APPROVED MINUTES OF THE MEETING

May 21, 2009

Project: Alaskan Way Viaduct and Seawall Replacement

SOUTH PORTAL CONCEPT A

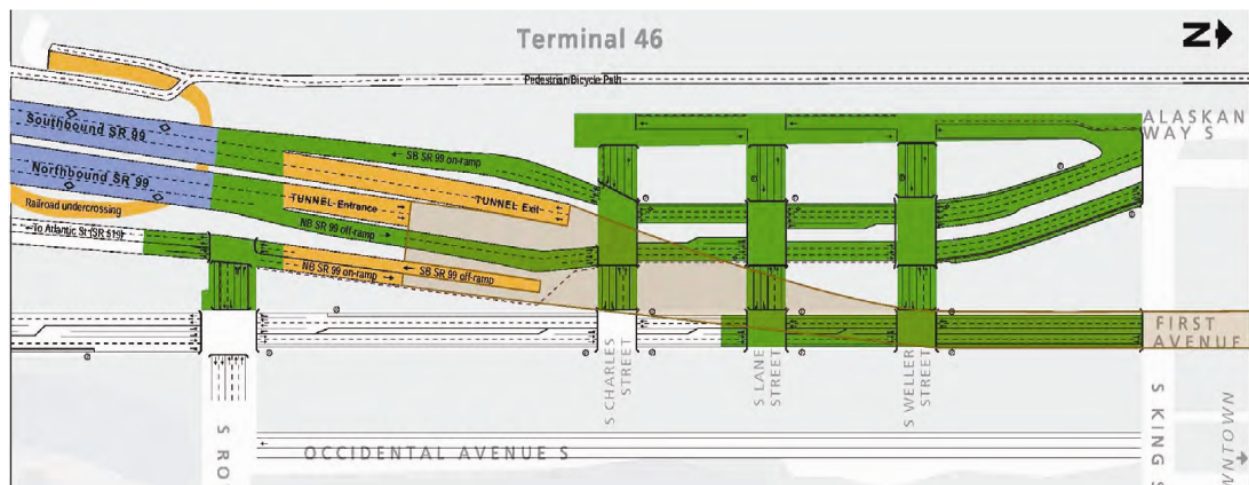
South Portal Concept A is the Preferred Concept. We like the graceful transition between the tunnel and surface streets in the city. New city blocks will be created. The concept minimizes elevated ramps and maintains an urban environment. The pedestrian bike trail will be included to the west of the southern terminus of the tunnel.

At the north portal, will developable land in blocks be created as at the south portal?

We are not disrupting the north as much as the south. In the south you have a large industrial site that will be redefined with the new street grid. There will be opportunities, but they will be subtler. It's more about connectivity up here.
